Model	Model Code	Year Model	Issue Date
CIVIC 3D	FN1, FN2, FN3, FN4	07, 08, 09, 10	29-11-10
CIVIC 5D	FK1, FK2, FK3	06, 07, 08, 09, 10	Originator Product Technical/QIC HUK (United Kingdom)

## Powered Door Mirrors Do Not Fold Civic 3 & 5 Door Only (LON Information Revised)

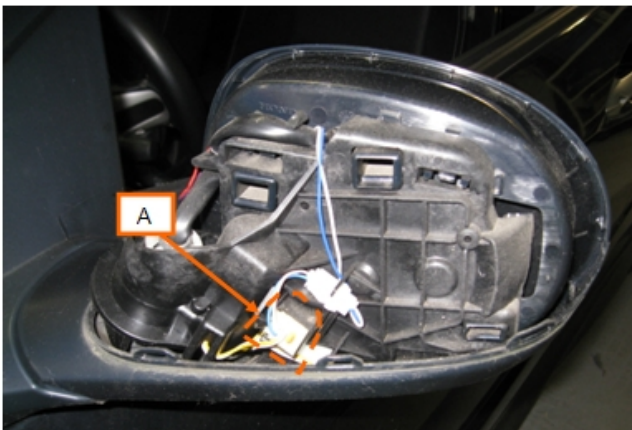
The shut off device within the door mirror fails.

Please refer to image A below for location of the Shut off device.

The shut off device has been modified.

Previously the repair for this symptom would have been to replace the entire mirror assembly, however the shut off device has now been made available as a service part.

If these symptom are encountered, replace the shut off device only.
